*City of El Paso – City Plan Commission Staff Report*

**Case No:** SUSU16-00042 Parra Medical Complex  
**Application Type:** Resubdivision Combination  
**CPC Hearing Date:** July 14, 2016  
**Staff Planner:** Vanessa Munoz, (915) 212-1644, [munozv@elpasotexas.gov](mailto:munozv@elpasotexas.gov)  
**Location:** North of Trawood and East of George Dieter  
**Acreage:** 1.552  
**Rep District:** 6  
**Existing Use:** Commercial  
**Existing Zoning:** C-1/c, A-O (Commercial/condition), (Apartment/Office District)  
**Proposed Zoning:** C-1/c, A-O (Commercial/condition), (Apartment/Office)  
**Nearest Park:** John Lyons (0.26 miles)  
**Nearest School:** Tierra Del Sol Elementary (0.62 miles)  
**Park Fees Required:** \$1,550.00  
**Impact Fee Area:** N/A  
**Property Owners:** Guillermo Parra and Juanita Parra  
**Applicant:** Guillermo Parra  
**Representative:** G-3ngineering

**ATTACHMENT 3**

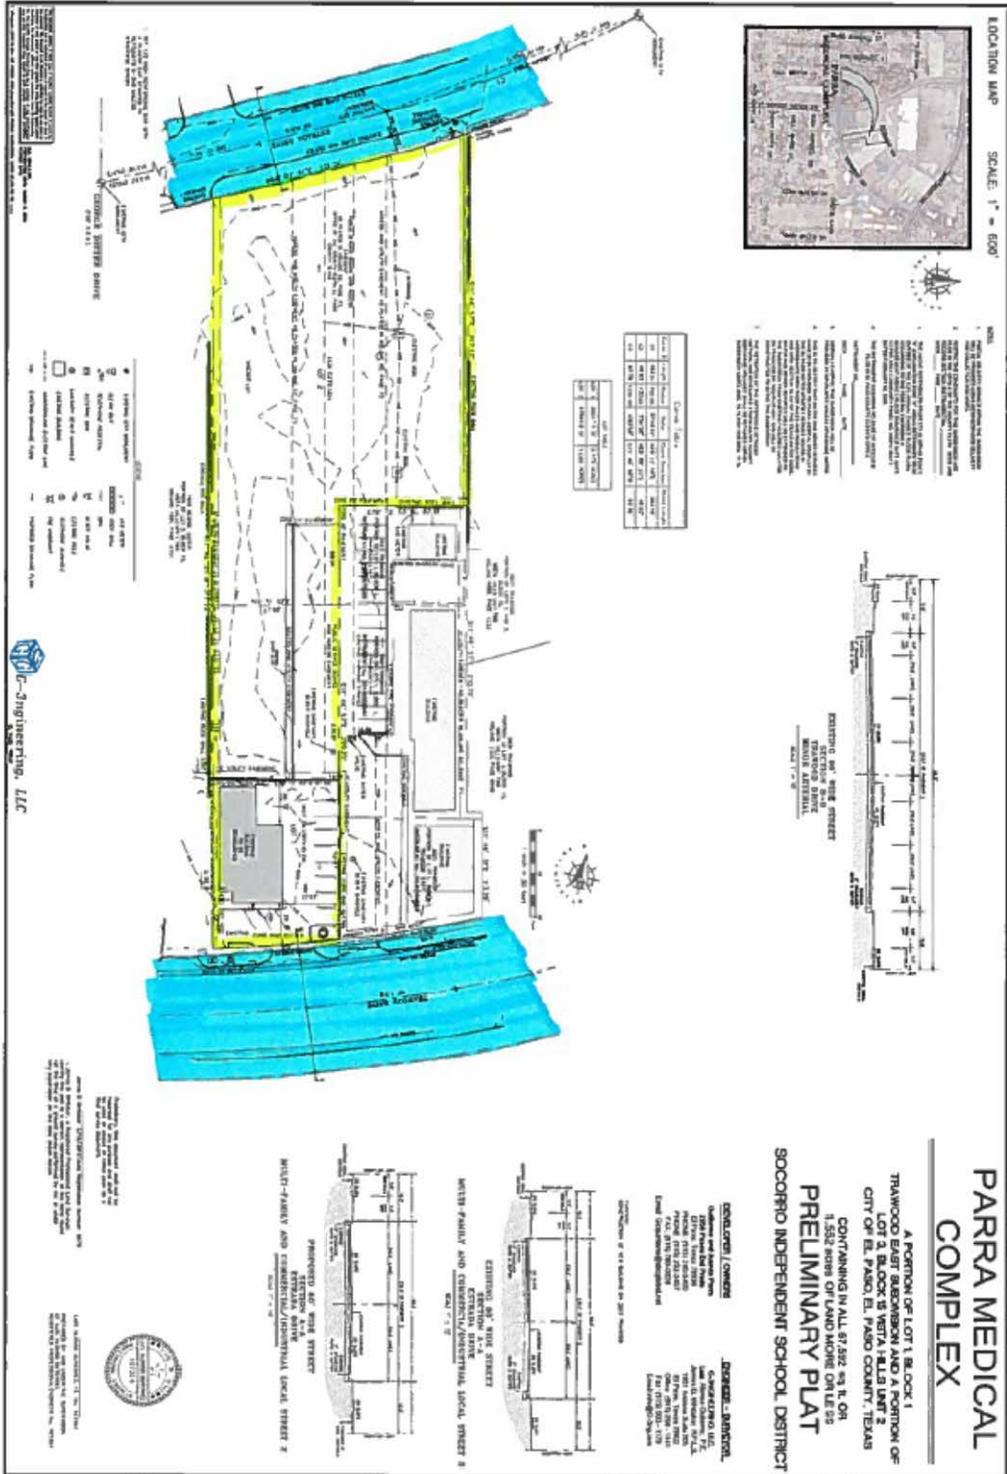
1. Show existing and proposed drainage flow patterns on the preliminary plat. Identify the discharge location for all storm-water runoff and provide pond location.
2. Add modified note on both preliminary and final plats: “The retention of all historic and developed storm-water runoff discharge volumes is required within this subdivision's limits in compliance with all provisions of (DSC, 19.19.010A and DDM, 11.1).”
